Planning Application No. A/YL-KTN/1198

Table A: Responses to Departmental Comments

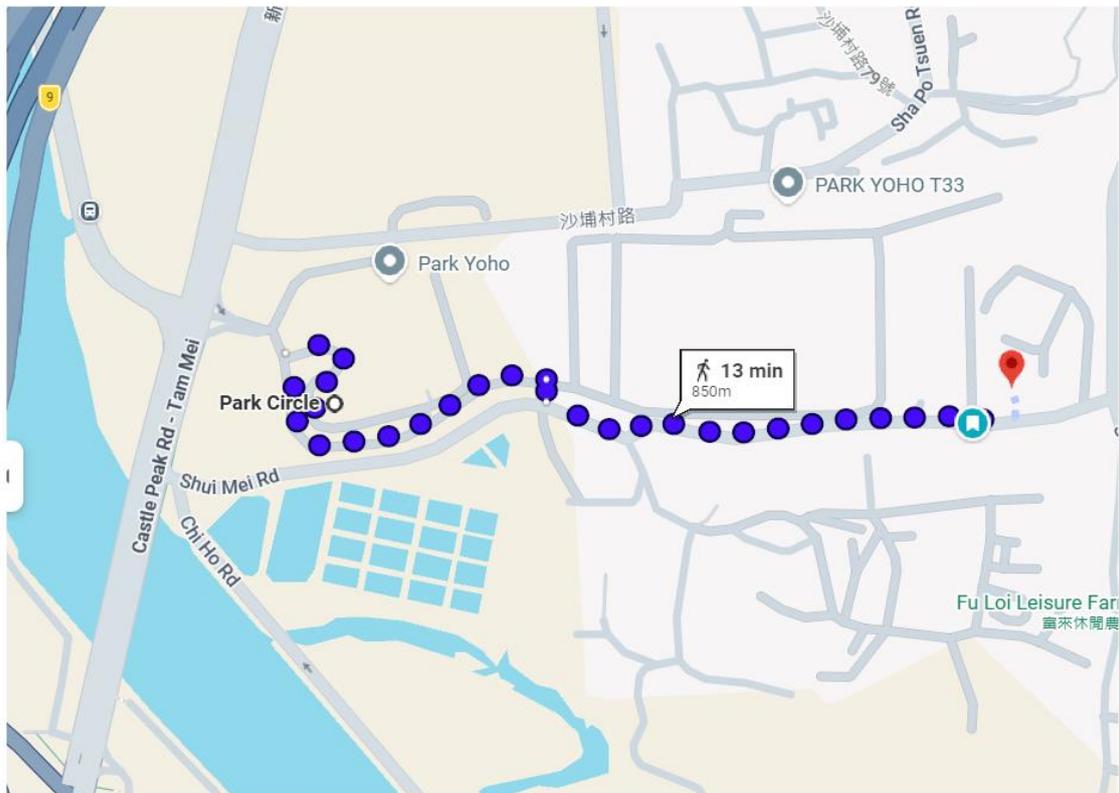
3	<p>The applicant should demonstrate the smooth manoeuvring of vehicles to / from Shui Mei Road and within the site;</p>	<p>請看 附件 5：Swept Path Analysis。</p>
4	<p>The applicant should provide nearest public transport services and indicate on the layout plan;</p>	<p>申請人可從乘坐公共交通工具到峻巒交通總匯，包括路線：九巴 68 號、68F 號、268M 號；以及專線小巴 620 及 624 號。</p> <p>下車後，步行約 12 分鐘即能到達申請地點。(請看下圖)</p>
5	<p>The applicant should note the local access between Castle Peak Road - Tam Mi and the site is not managed by this Department.</p>	<p>申請人知悉。</p>
